Access Compliance Report

Public Rights-of-Way

Intersection ID: 27388	Main Street: BRIXHAM_HILL_AV	Cross Street: DON_LOCHMAN_LN	Location: NE
ADA ID: 36E973552FEA	Ramp Type: Perp	Initial Pass/Fail: Fail	Overall Compliance: No
Severity Score: 13.75			
Codes/Mitigation Info/Possible Solution		Field Measurements/Component Compliance

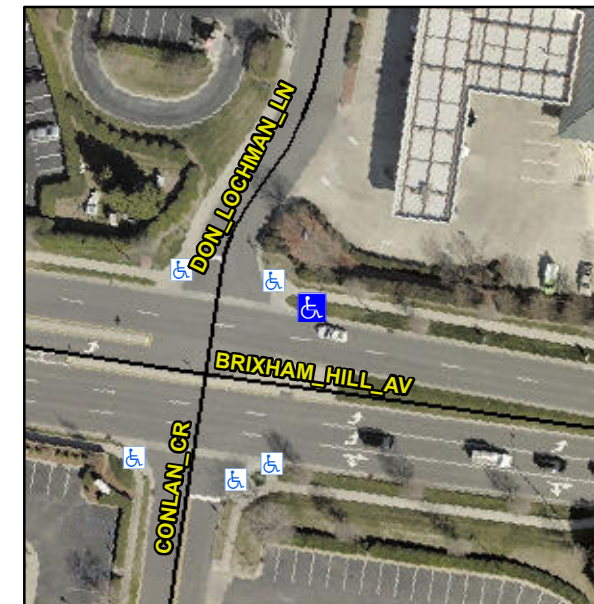
Not Found, R304.2.2, R304.5.3

Compliance	Description	Data	Compliance	Description	Data
N/A	Ramp Length (in)	95.0	No	Ramp Slope (%)	8.8
Yes	Ramp Width (in)	60.0	No	Ramp XSlope (%)	4.0
N/A	Flare Type LT	N/A	N/A	Flare Type RT	N/A
N/A	Flare Slope LT (%)	N/A	N/A	Flare Slope RT (%)	N/A
N/A	Flare Traversable LT?	N/A	N/A	Flare Traversable RT?	N/A
N/A	Landing Length (in)	N/A	N/A	DWS Provided?	N/A
N/A	Landing Width (in)	N/A	N/A	DWS Contrast?	N/A
N/A	Landing Slope (%)	N/A	N/A	DWS Length (in)	N/A
N/A	Landing X Slope (%)	N/A	N/A	DWS Full Width?	N/A
N/A	Landing Curb? (Y/N)	N/A	N/A	DWS Offset (in)	N/A
N/A	Shared Landing?	N/A			
N/A	Gutter Ponding?	N/A	N/A	Gutter Slope (%)	N/A
N/A	Gutter Lip Ht (in)	N/A	N/A	Gutter X Slope (%)	N/A
N/A	Painted X Walk1?	No	N/A	Painted X Walk2?	N/A
	X Walk 1 Direction	To SW		X Walk 2 Direction	N/A
N/A	X Walk 1 Width (in)	N/A	N/A	X Walk 2 Width (in)	N/A
	X Walk 1 Slope (%)	0.3		X Walk 2 Slope (%)	N/A
	X Walk 1 X Slope (%)	2.7		X Walk 2 X Slope (%)	N/A

Remove & Replace Entire Ramp.
